Release Note for AIC SAS 6G 3U16-2 Expander

Jun 27, 2014

02/15/2012 (firmware 1.11.1.1 + mfg 1.1.x.1)

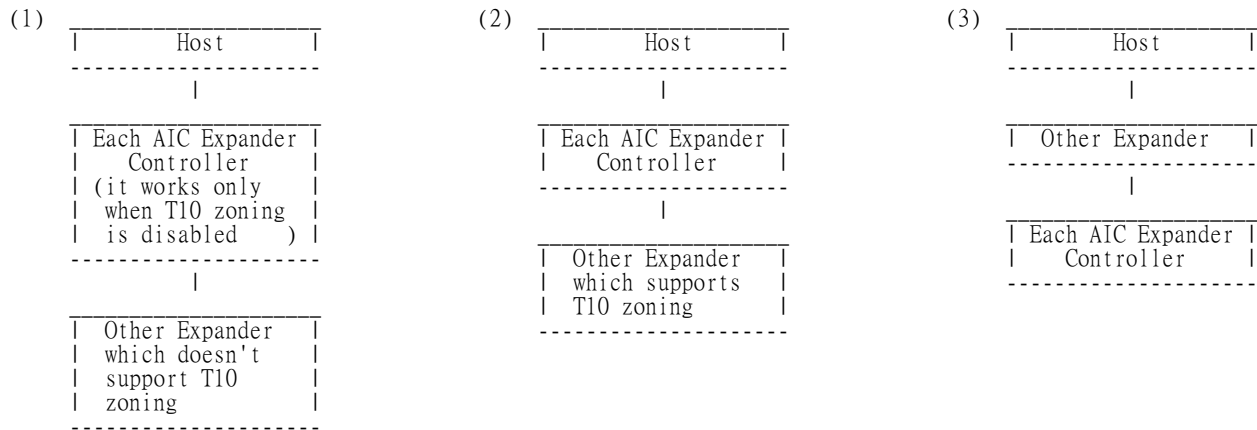
1. Both LEDs (blue and red) per drive can be controlled by Host HBA or RAID card.
2. Compatible with Adaptec 3G HBA and RAID cards.
3. Support T10 zoning.
4. In dual-Expander configuration, Host can control drive's LEDs (blue and red) via either Expander.
5. The firmware on Expander automatically configures the number of Fans (cooling elements) during the first boot after the Expander board is attached to the backplane, but the number of cooling elements in SES report may be incorrect on the first boot. After the second boot, cooling elements work well.
6. The order of drive slot id is changed. The order in firmware 0.6.x.x is from top to bottom, then from left to right, and the first slot id (the top-left drive) in SES page is 0. The order in firmware 1.11.1.1 is from left to right, then from top to bottom, and the first slot id (the top-left drive) in SES page is 1.
